LONG-TERM MANAGEMENT PLAN NORTHEAST CAPE FUDS

ST. LAWRENCE ISLAND, ALASKA

**Formerly Used Defense Site Nos.
F10AK0969-03 and F10AK0969-05**

**FINAL
SEPTEMBER 2016**

JACOBS	DATE:	06 JAN 2016	PROJECT MANAGER:	K. MAHER	FIGURE NO.:	A-3

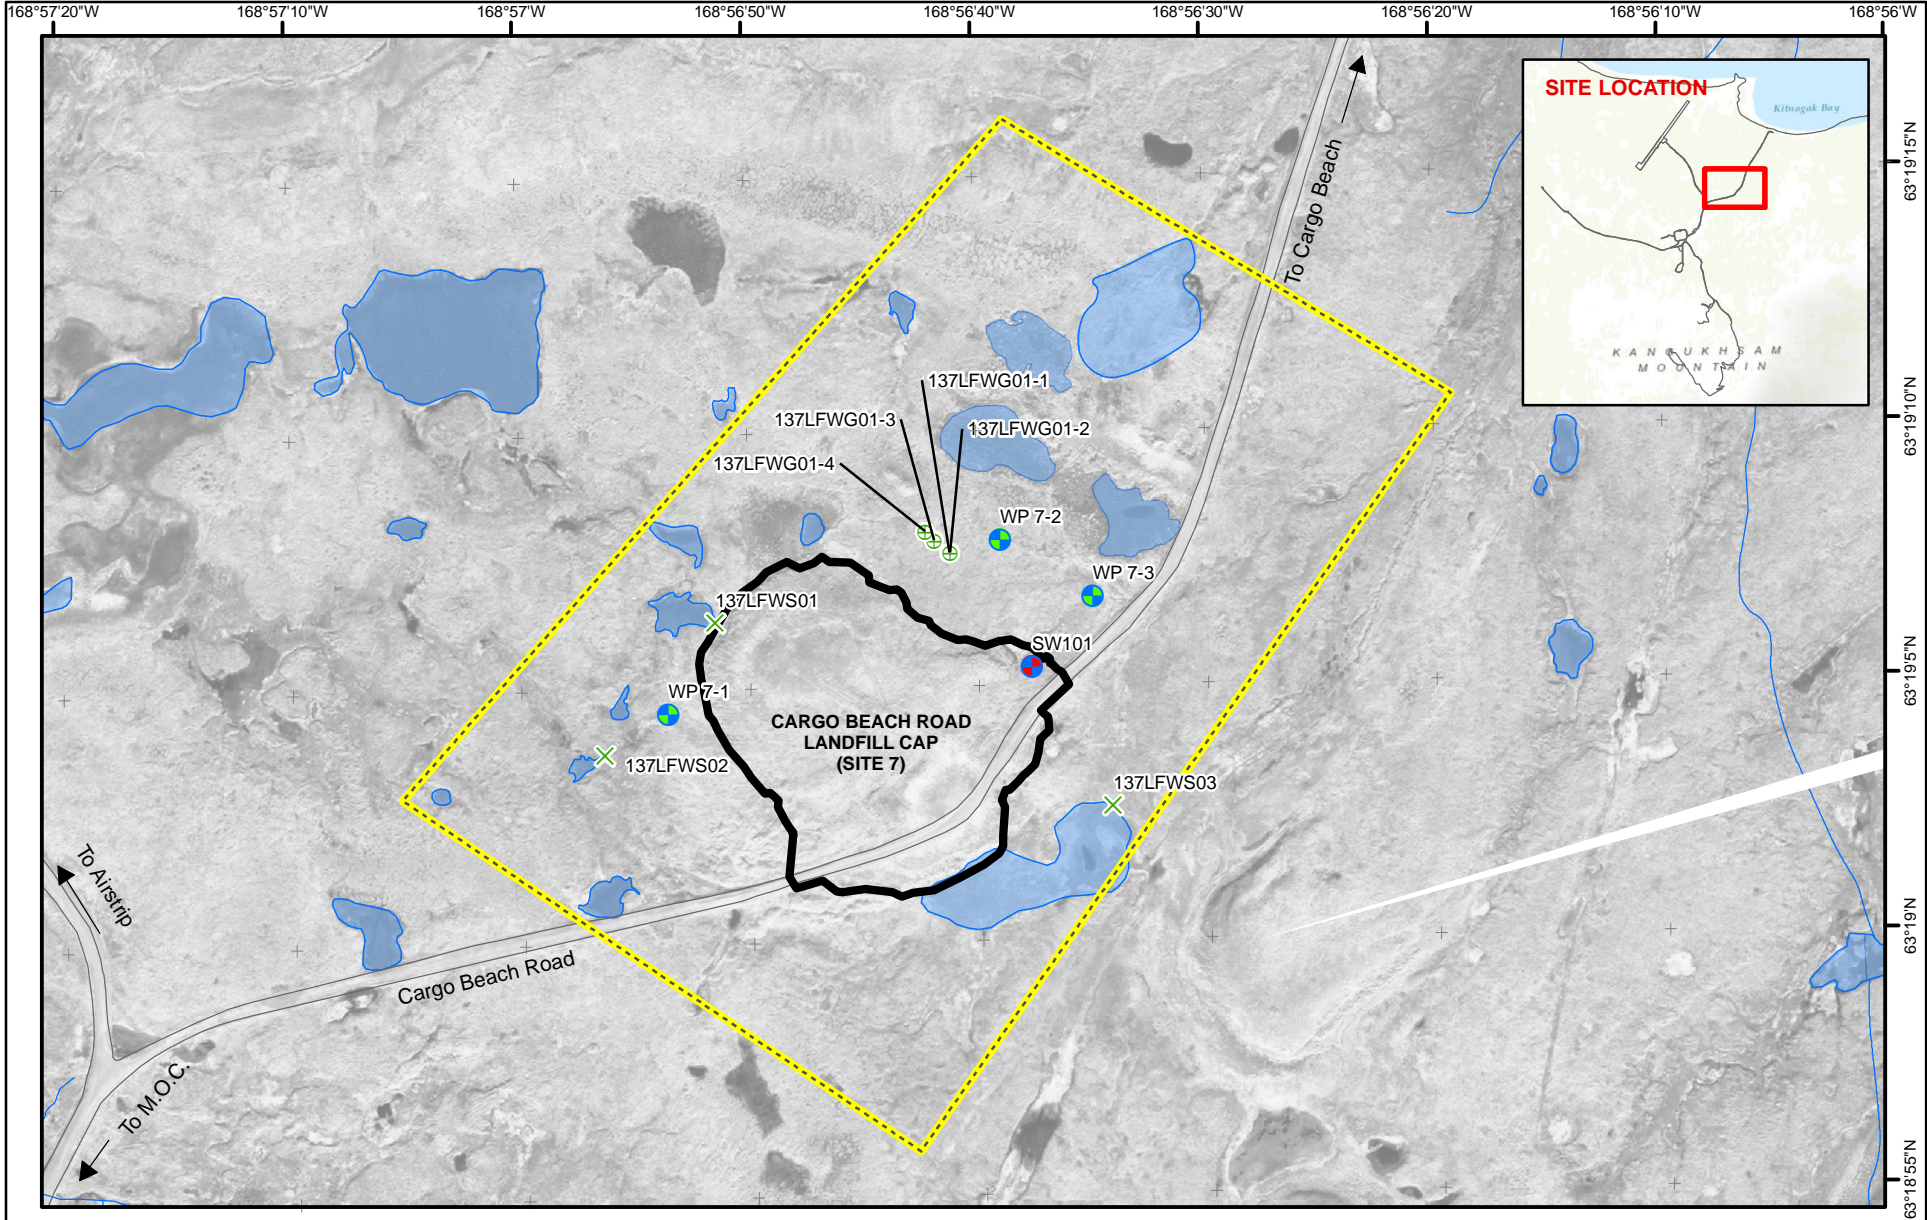
62.		Figure A-3	<p>The applicable narrative sections of the LTMP should discuss the rationale for selecting the depicted LUC areas i.e. Non-drinking Water Area; gradient, AOC of known residual contamination, etc. Discuss the size, placement of the area in relation to the site boundary, boundary of known contamination above applicable criteria, etc.</p>	<p>Accepted. The following text will be added as the last sentence of the first paragraph of Section 2.2: “The extent of the boundaries for the ‘Non-drinking Water Areas’ were established by placing each site, or sites,</p>

**NORTHEAST CAPE
 SITE 8, PETROLEUM, OIL AND LUBRICANT SPILL
 SAINT LAWRENCE ISLAND, ALASKA**

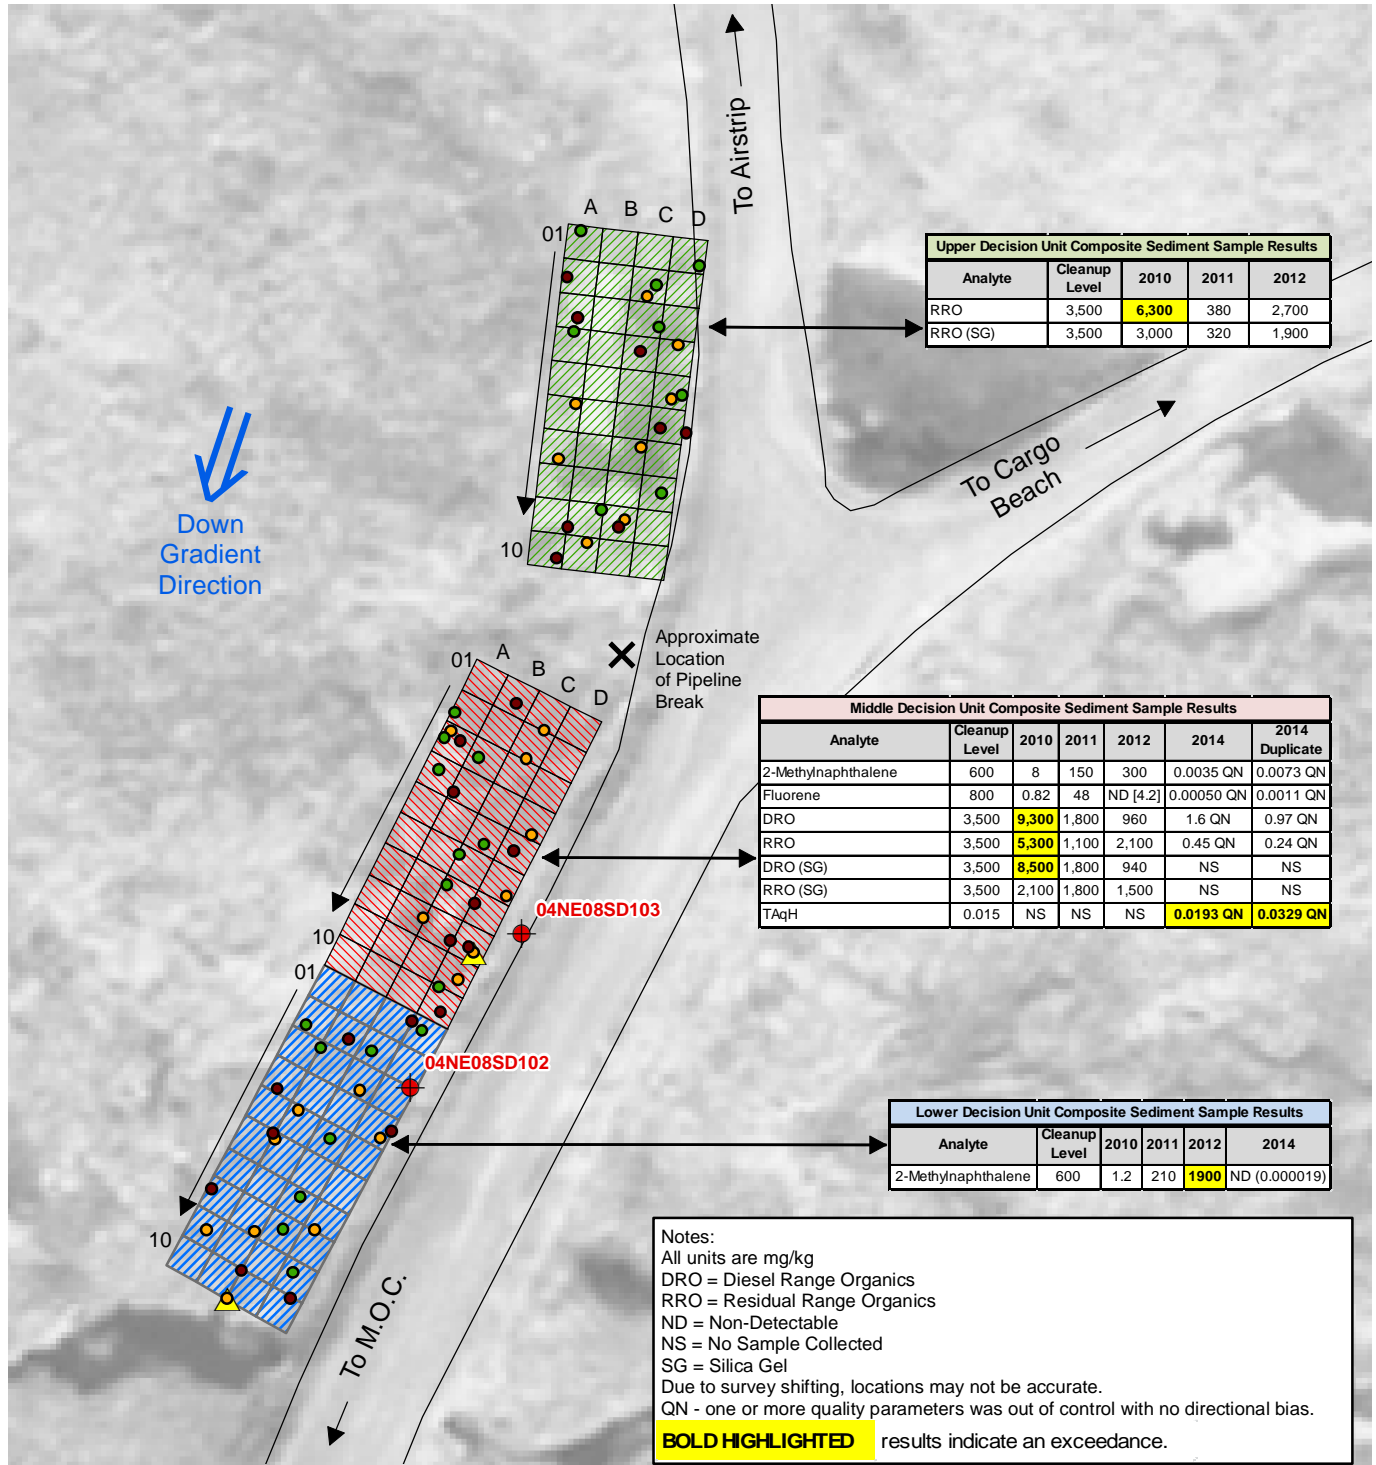
#	Page #	Section	ADEC Comment	Response
				at the center of a conservative buffer area.” ADEC-Accepted August 24, 2016
63.		Figure A-4	Why does the middle decision unit data box title include groundwater? Shouldn't this be surface water? If so then the applicable surface water results should be called out and detailed on the figure.	Accepted. Data boxes in Figure A-4 present sediment results. The title of the Middle Decision Unit data box will be revised to state: “Middle Decision Unit Composite Sediment Sample Results”. ADEC- Accepted August 24, 2016

NORTHEAST CAPE MOC MONITORING WELL LOCATIONS AND SELECT SAMPLE RESULTS NORTHEAST CAPE, SAINT LAWRENCE ISLAND, ALASKA			
JACOBS	DATE: 20 JUN 2016	PROJECT MANAGER: K. MAHER	FIGURE NO: A-7

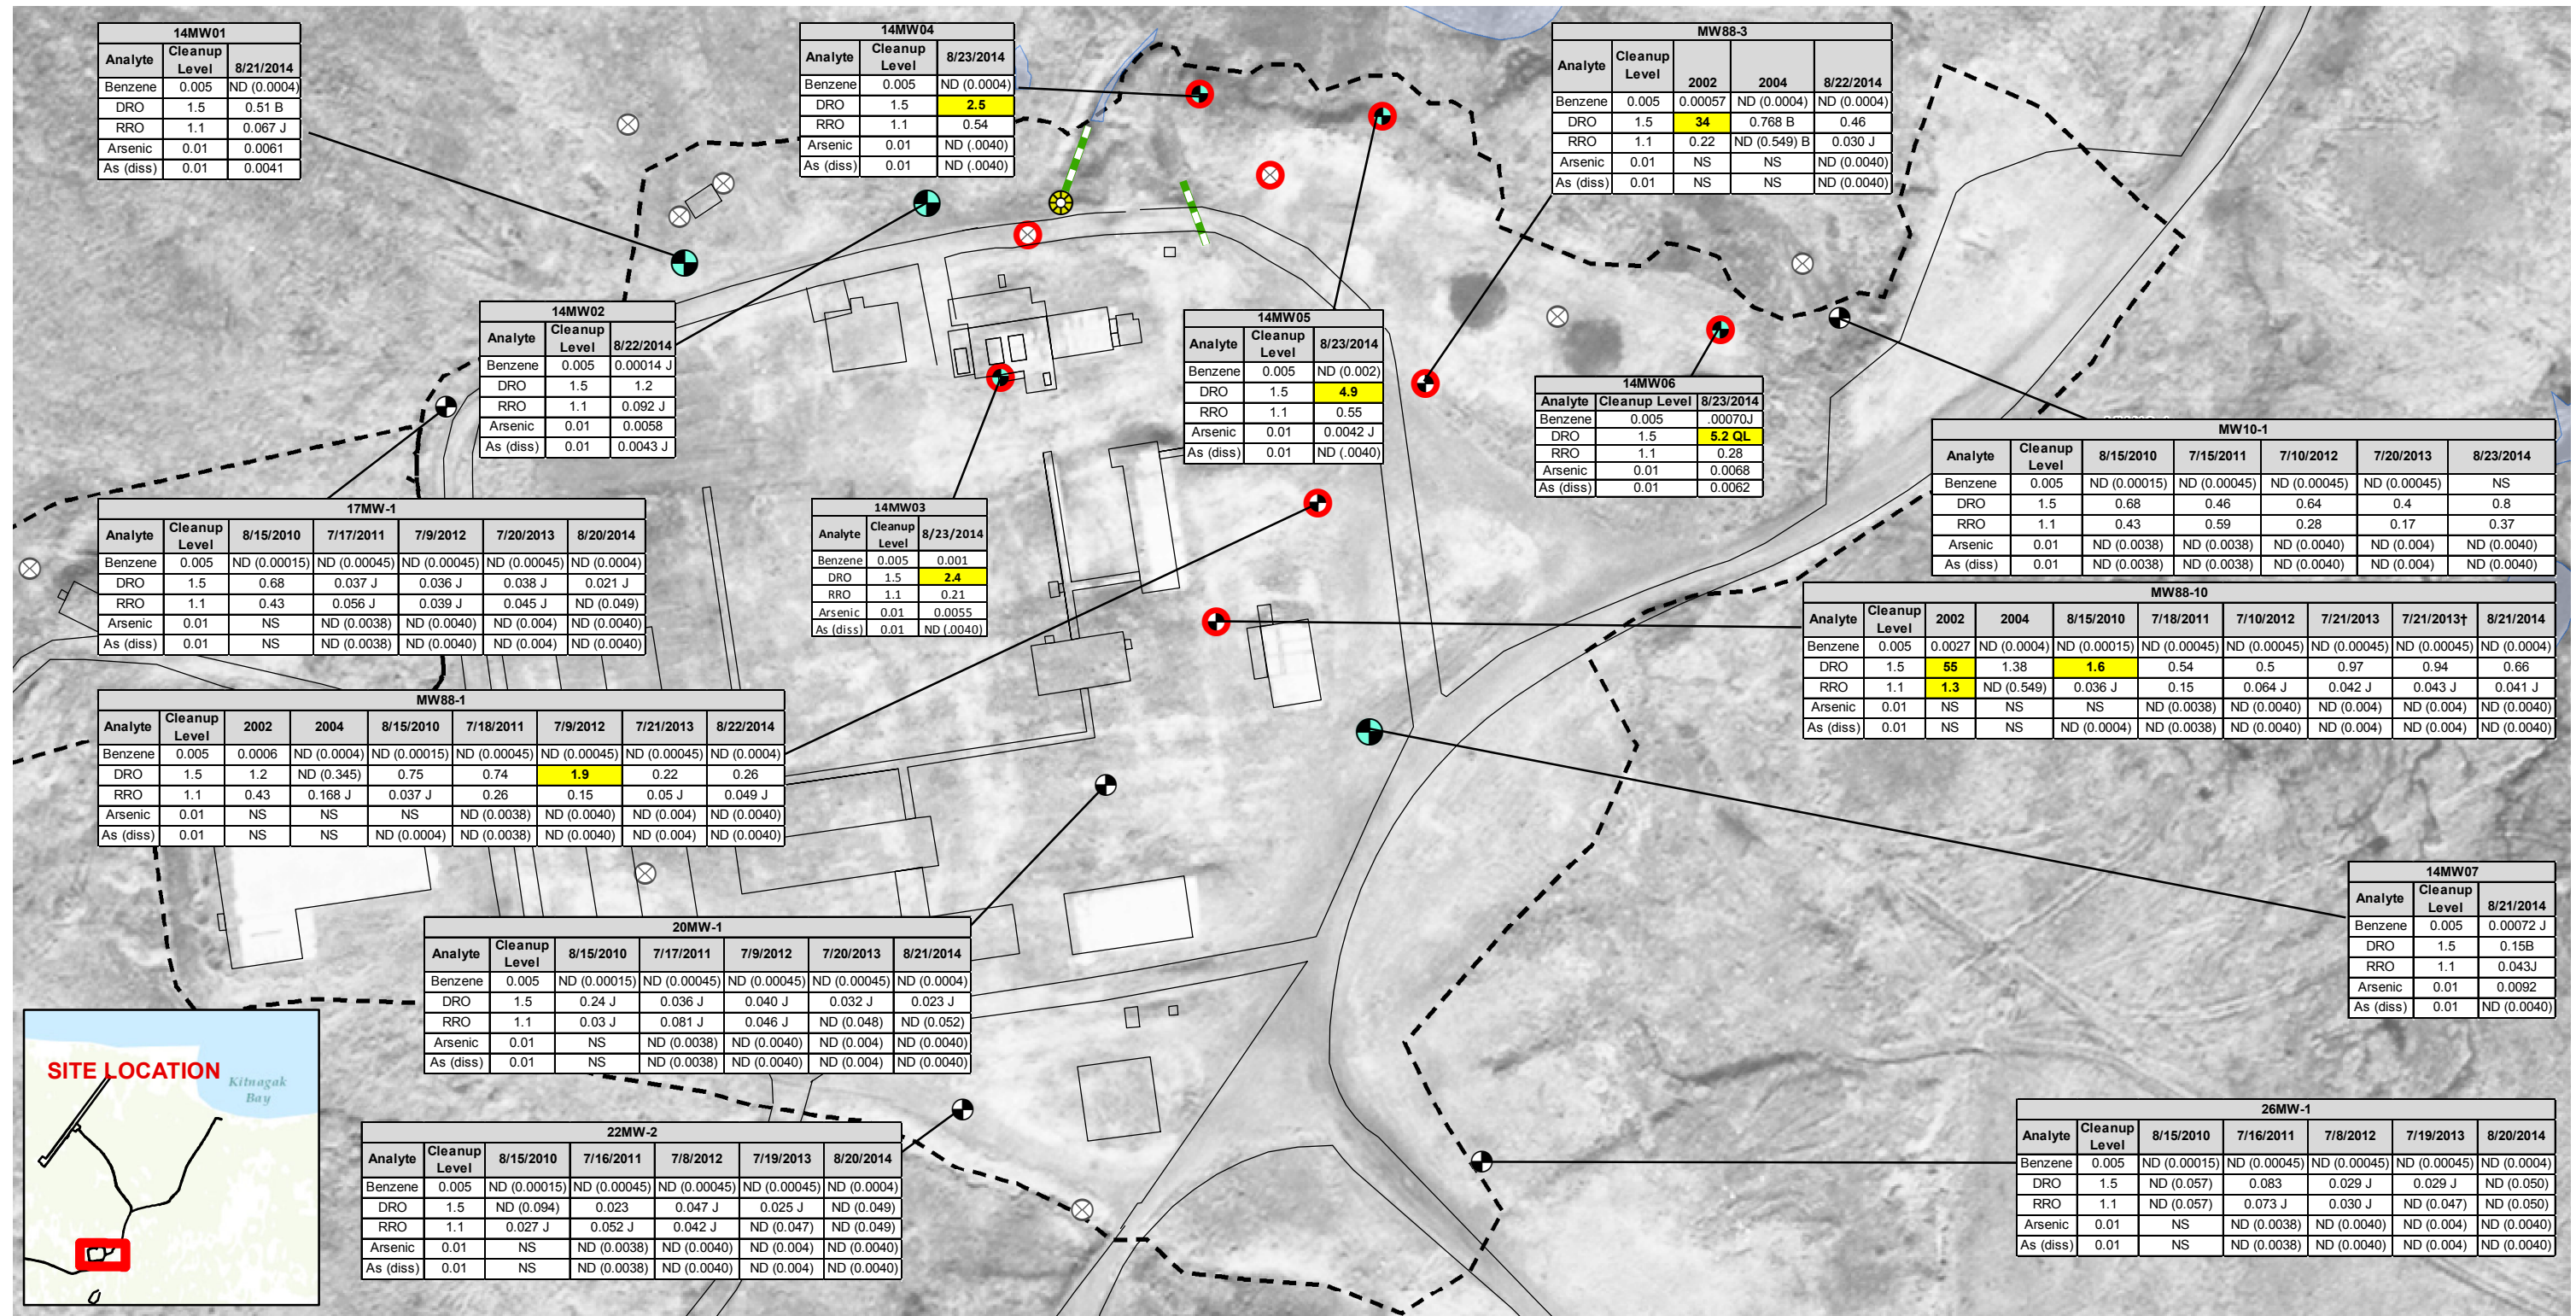
64.		Figure A-7	A figure note should be added that states that wells depicted as abandoned were either demolished during removal action activities or decommissioned due to site conditions.	Accepted. The following text will be added to the ‘Note’ Section of Figure A-7: “Abandoned wells were decommissioned due to site conditions or demolished during Remedial Actions”. ADEC- Accepted August 24, 2016
